Response to Information Request for a Material Change of Use for a Multiple Dwelling at 31 Glenvale Road, Newtown Qld 4350 (Council Ref.: MCUI/2026/1261)

Figure 2 – Site Frontage

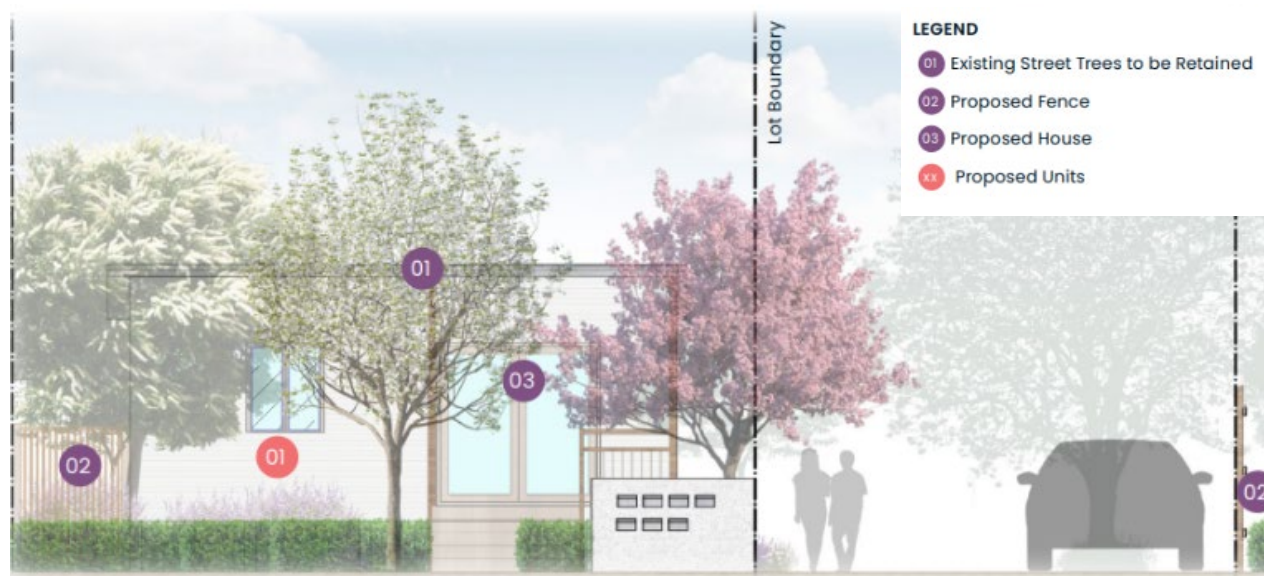
In accordance with Performance Outcome PO18 of the Medium Density Residential Code the proposed development is required to be designed to a high aesthetic standard. The development should provide clear and visible entries and prominent features addressing the street frontage.

Provide amended plans for the southwestern unit located at the site frontage to be orientated to address Glenvale Road. The entrance of the unit is to be located on the Southern elevation of the unit, opening directly to street frontage. Separate pedestrian entry and pathway is required to be provided from Glenvale Road to the relocated front entrance of the unit.

The design of the unit fronting Glenvale Road has been repositioned within the site to directly address the street frontage. The front door and entrance to the property is provided directly from the street. The revision to the orientation of the unit is proposed to enhance the view of the development from the streetscape and appear in a consistent development pattern. As part of the refinement to the site layout, the visitors parking and refuse storage areas have been relocated to be further positioned within the site and out of direct view from the street. The revised location maintains a functional layout and enhances the appearance of the development from the street frontage.

Figure 4 – Proposed Bin Storage Locations

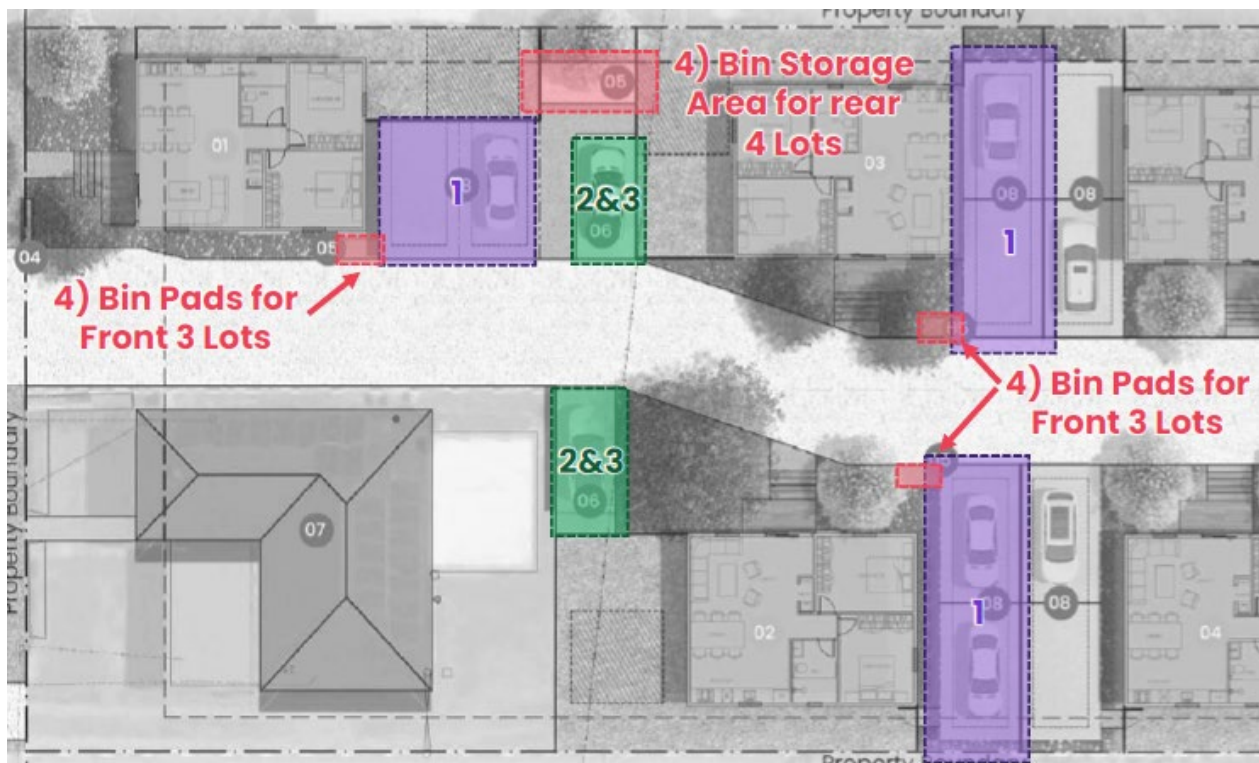
Performance Outcome PO11 of the Low Density Residential Zone Code and Performance Outcome PO16 of the Medium Density Residential Code required refuse container storage area be provided with convenient access, away from habitable rooms, and screened to provide visual amenity.

it is unclear whether the current location of the refuse storage are able to appropriately address the above listed PO. In addition, relocation of the proposed refuse storage area is required to facilitate the site layout issue identified above.

Provide amended plans to demonstrate a refuse storage areas in accordance with the requirement outlined in the Planning Scheme.

The refuse storage areas have been relocated to appropriate bin pads and storage areas within the revised site layout. As shown in **Figure 4** below, the refuse storage areas are located adjoining the visitor's car parking space west of the site for the rear units. The front units are provided a bin pad that can store two wheelie bins per bin pad location. The existing dwelling house will maintain the existing storage and servicing locations. For further information, please refer to the Waste Management Plan contained in **Attachment C**.
